2. TUSCAN VILLAGE MASTER PLAN UPDATE 3.0

PLANNING BOARD AGENDA FOR SEPTEMBER 22, 2026 - 7:00 PM

1. **Tuscan Village Master Development Site Plan** – Conceptual Discussion on revised master plan for Tuscan Village to include 120-key hotel, 392 apartments, 72 workforce housing units, medical office, general office, bank, and restaurant uses at 14-24 Tuscan Blvd, Map 107, Lot 12605. Continued from 7/28/2026.

TUSCAN VILLAGE MASTER PLAN UPDATE

PROJECT NO:	FILE:	DRAWN BY:	CHECKED:	APPROVED:	SHEET:
M1775-005	M1775-005_WEST VILLAGE DISTRICT & PARKING PLAN.dwg	MAB/BKC	BKC/JMP	JMP	6

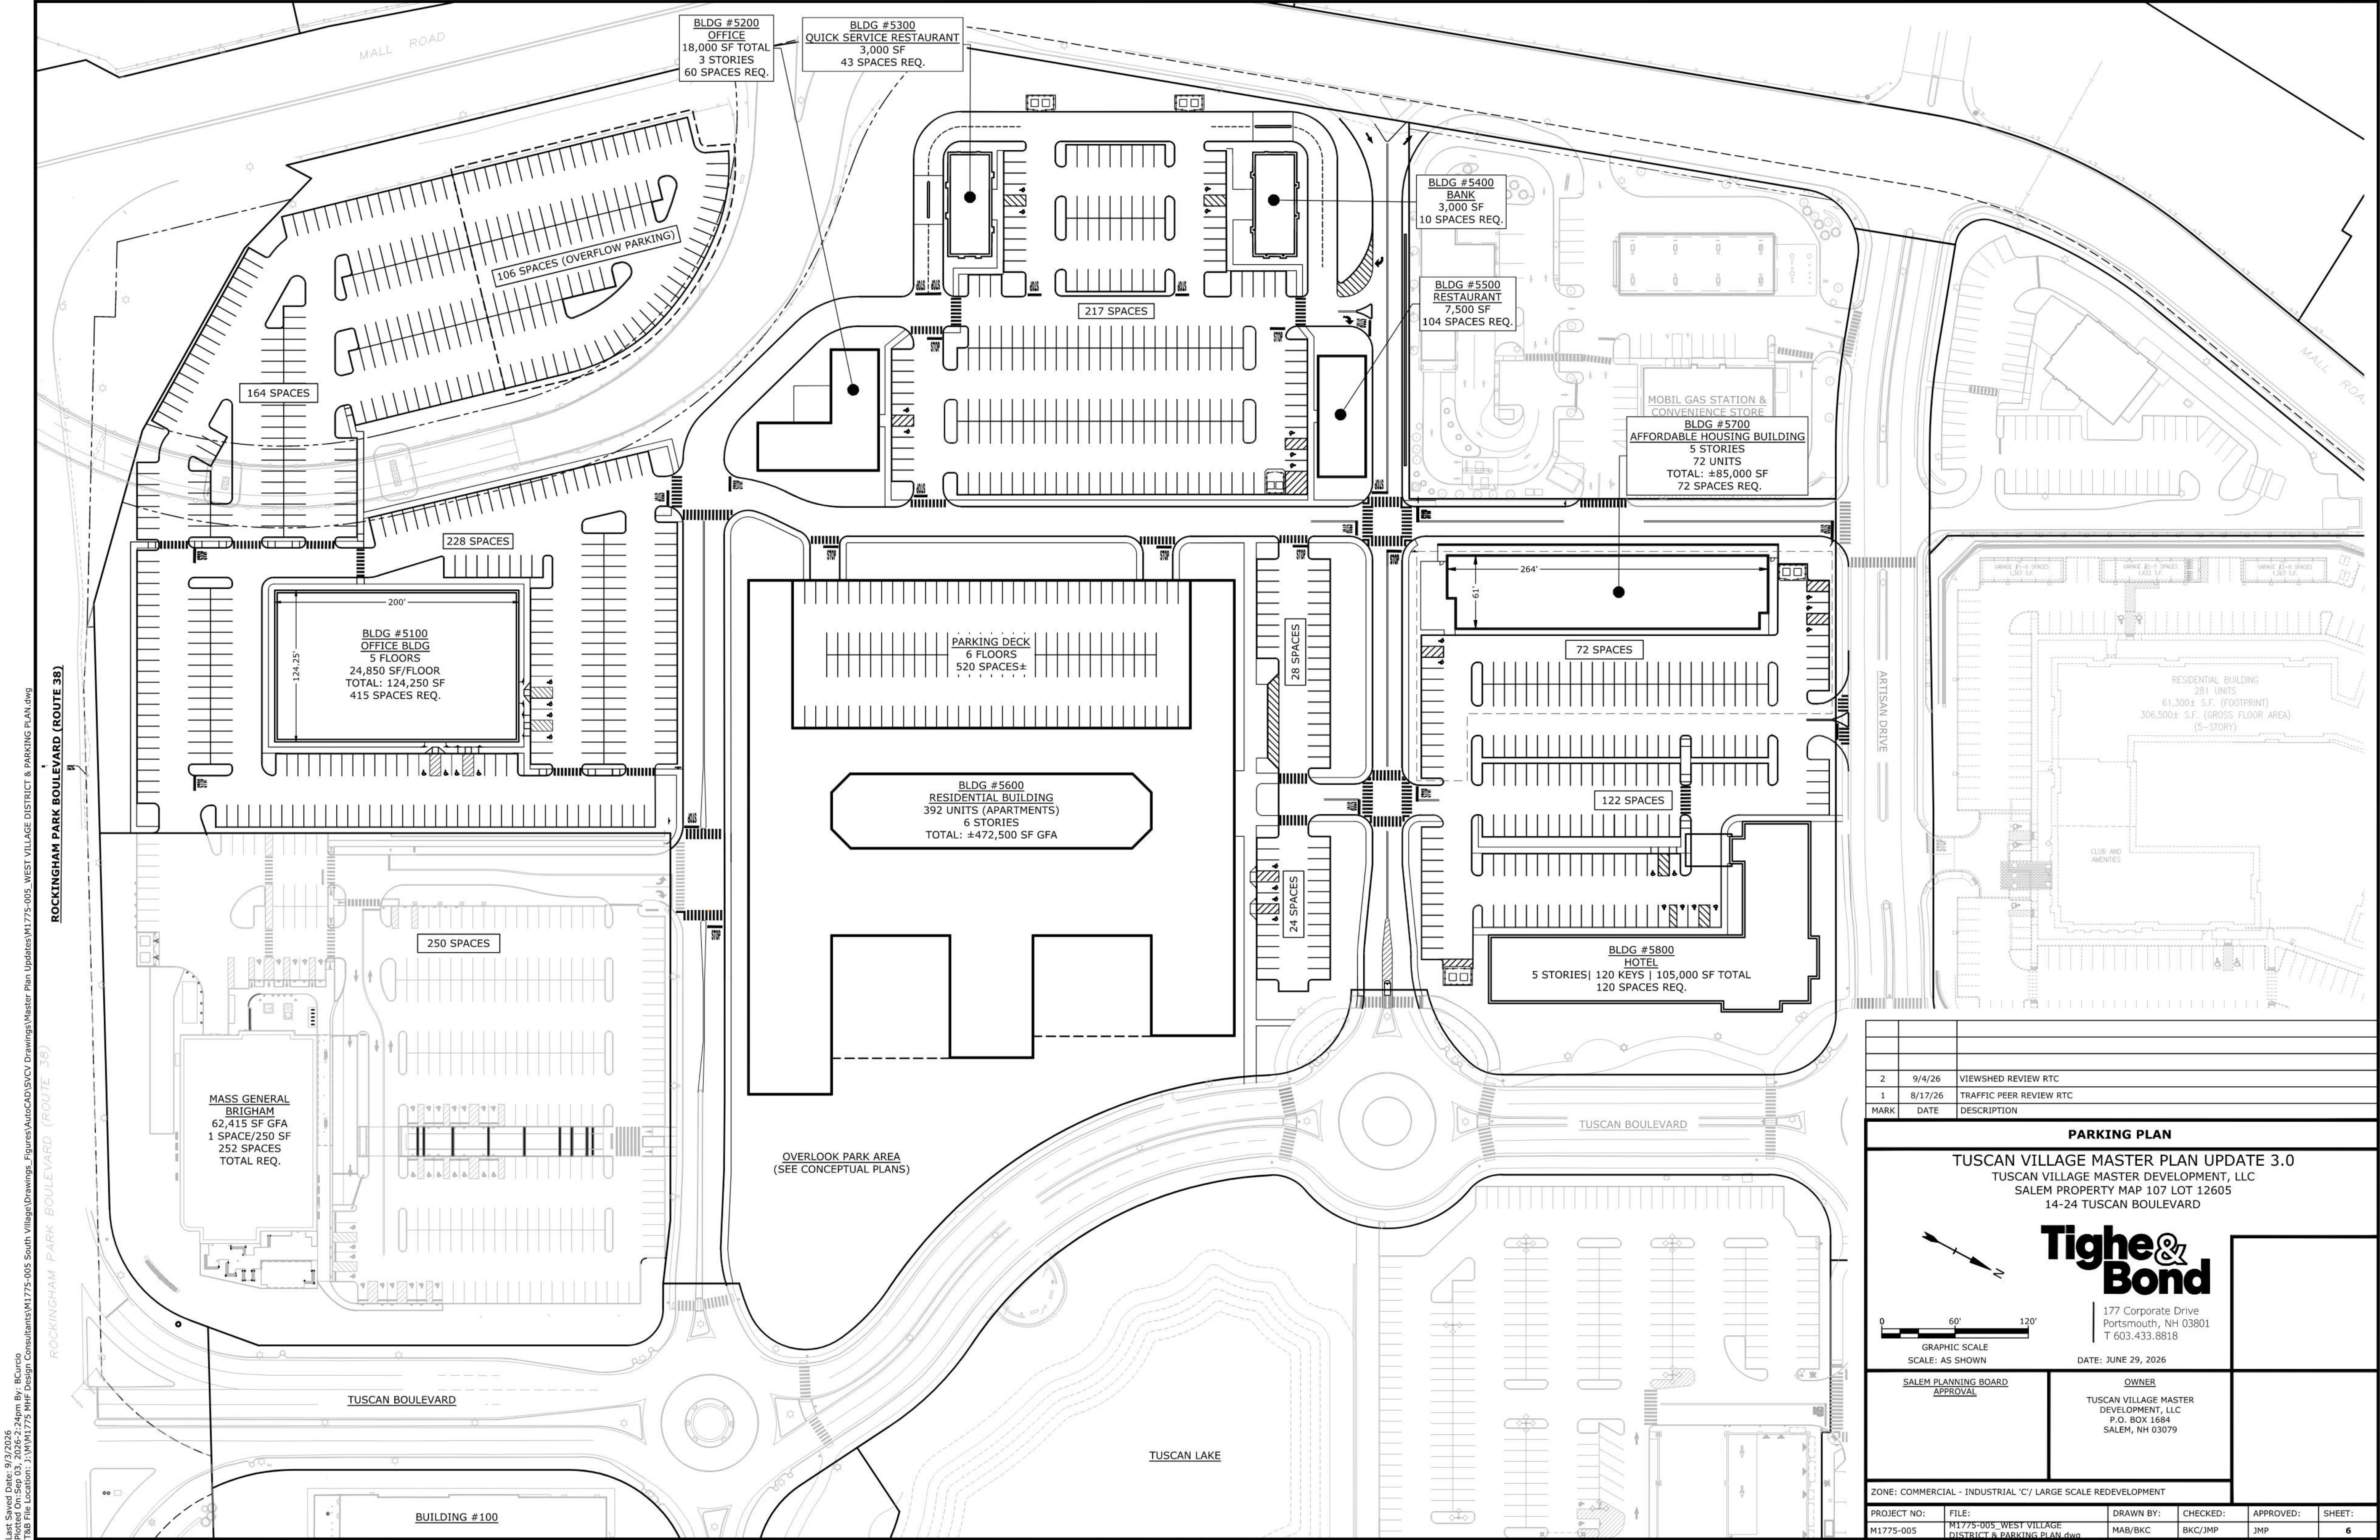
The Parking Plan (Sheet 6) indicates 4 accessible spaces for Building 5600 (condominiums) out of the 73 spaces in the surface lot. There is no indication of how many accessible spaces there are in the underground parking area (with 180 total spaces).

Sheet 6 also shows 2 accessible spaces opposite the middle of Building 5700 (workforce housing), plus four additional covered spaces on the first floor. It is unclear whether the covered spaces are dedicated to residents or whether they will be open and available to all.

Comment 47: *Additionally, there are several discrepancies between the parking space totals shown on the Parking Plan (Sheet 6) and the Parking Table Plan (Sheet 7). Building 5000 MGB Flyover Parking: 106 spaces reserved for the existing MGB building Building 5100 Office Building Flyover: short 22 or 23 parking spaces 398 provided Discrepancy: Parking Plan Sheet 6 requires 415 spaces Parking Table Plan Sheet 7 requires 414 spaces Building 5200 5500 Office Restaurant: short 11 parking spaces: 164 required, 153 provided Building 5300 5400 Fast Food Bank: +11 parking spaces (53 required, 64 provided) Building 5600 Apartments: 23 or +25 spaces reserved for only that building's use Discrepancy: Parking Plan Sheet 6 lists 572 spaces provided Parking Table Plan Sheet 7 lists 574 spaces provided Building 5700 Workforce Housing: exactly meets requirement: 72 spaces for 72 units Note: 5 of the 72 spaces are dedicated ADA parking, so if there are fewer than 5 residents in the building with ADA plates, there will not be sufficient parking for each unit. Building 5800 Hotel: +2 spaces (120 required, 122 provided) As shown above, the project is short by 20 to 21 parking spaces that are open to all users. This shortfall does not take into account the snow storage areas that are not shown on the plans, and are expected to reduce the number of available parking spaces within each parking lot during the winter.*

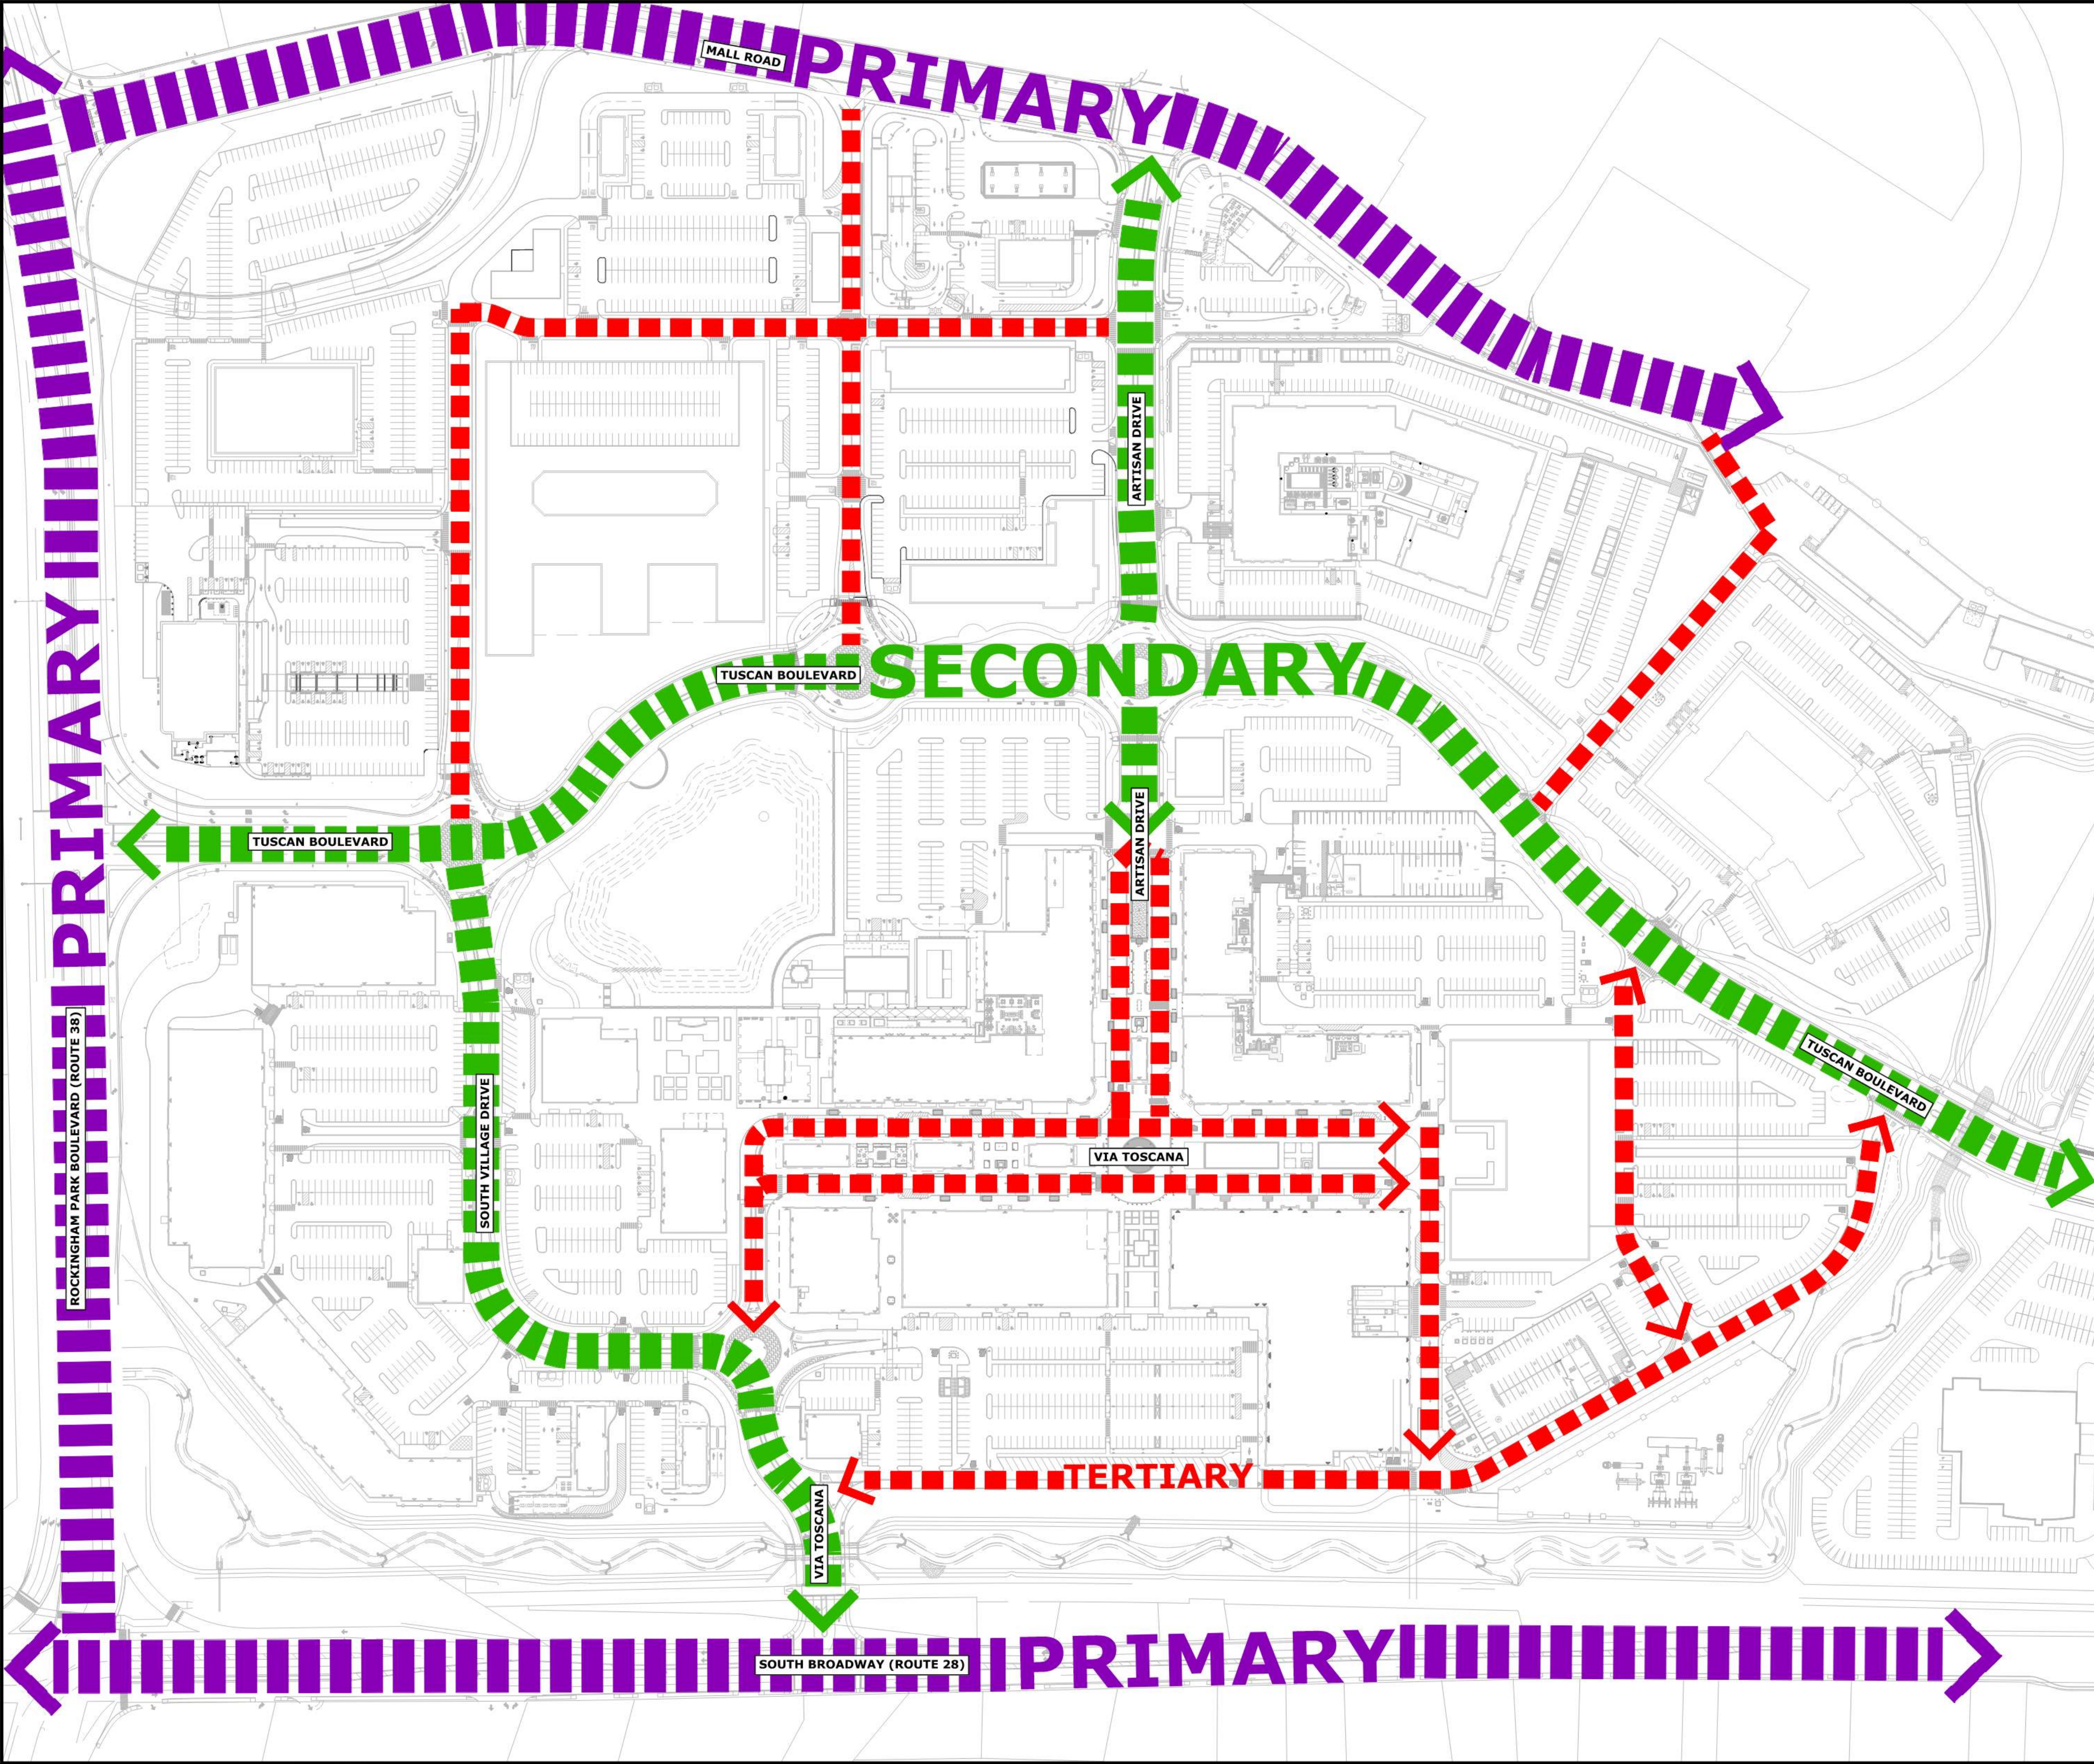
Comment: According to the updated parking calculations on Sheet 7, the West Village District provides 1,733 parking stalls (not verified); whereas the zoning regulations require 1,621 parking stalls (surplus = 87 parking stalls, excluding 25 non-shared spaces for Building 5600).
